EVALUATION OF PROPOSED CHANGES

Subject: Modification of the Control Room Emergency Air Treatment System (CREATS), changing of the Dose Calculation Methodology to Alternate Source Term (10CFR50.67) and revision of Ginna Technical Specification Sections 1.1, 3.3.6, 3.4.16, 3.6.6, 3.7.9, 5.5.10, 5.5.16 and 5.6.7.

This letter is a request to amend Operating License Docket # 50-244 for the R.E. Ginna Nuclear Power Plant.

Figure 1

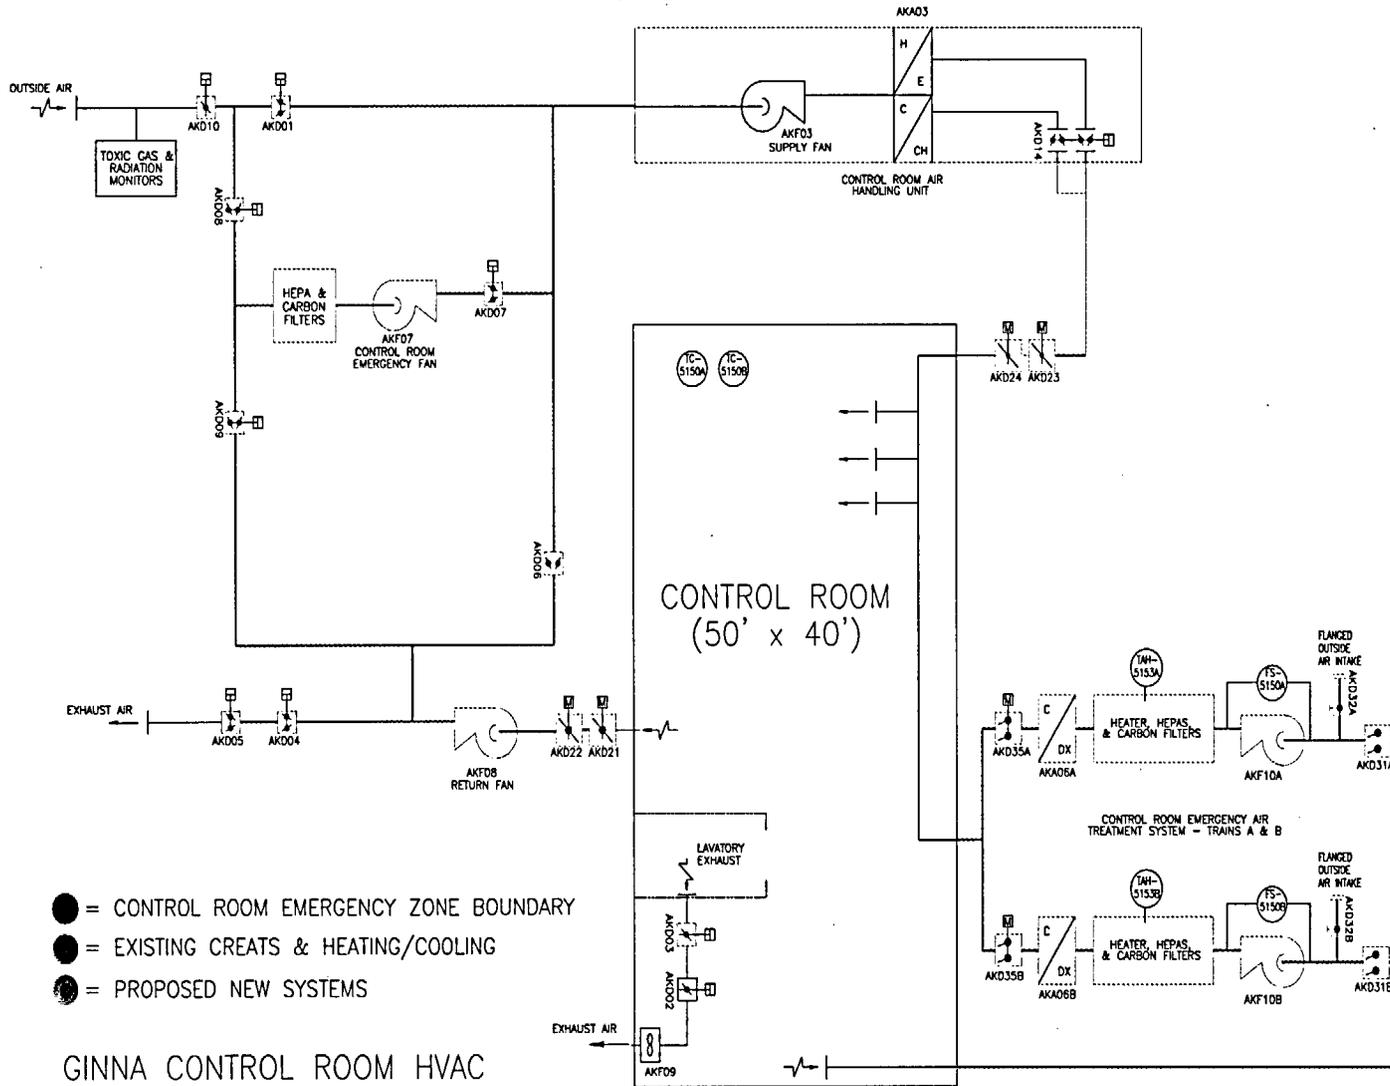
Short ducts sealed with blind flanges will be installed on the inside of the Control Room walls to provide a connection point for the interior ductwork (see A on Figure 1). Holes will then be cut from the outside of the control room wall along the internal radius of the short ducts. The interior blind flange plates will stay in place until the external system is installed and pressure tested.

After the new equipment is operational, new dampers AKD21, AKD22, AKD23 and AKD24 will be installed to provide emergency mode isolation of the normal HVAC system. These 4 dampers will be located in the Control Room/Relay Room stairwell. RG&E Design Analysis DA-NS-2000-070, Control Room Dose Simulation Removal of MUX Room Temporary Stairwell Enclosure (reference 8) documents the acceptability of the stairwell as an extended Control Room boundary.

Figure 3.4.16-1
Reactor Coolant DOSE EQUIVALENT I-131 Specific Activity Limit Versus Percent of RATED THERMAL POWER

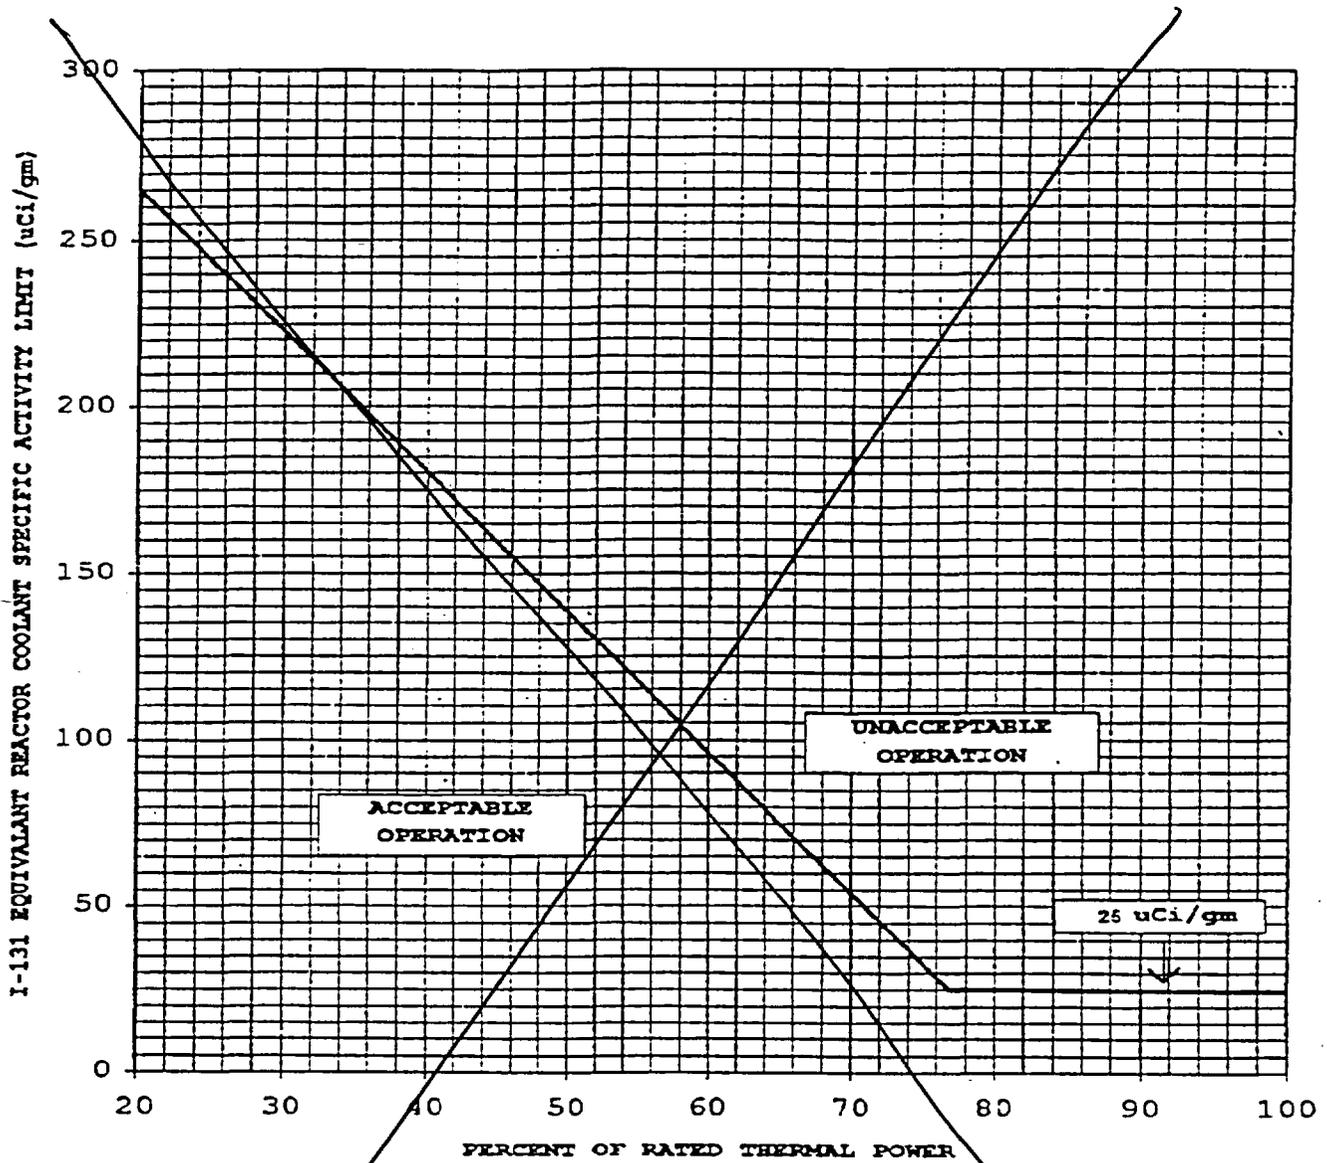
- Section 3.4.16 - RCS Specific Activity Limits will be revised to eliminate Figure 3.4.16-1 and provide a single limit for Dose Equivalent I-131 specific activity consistent with the new dose analysis.
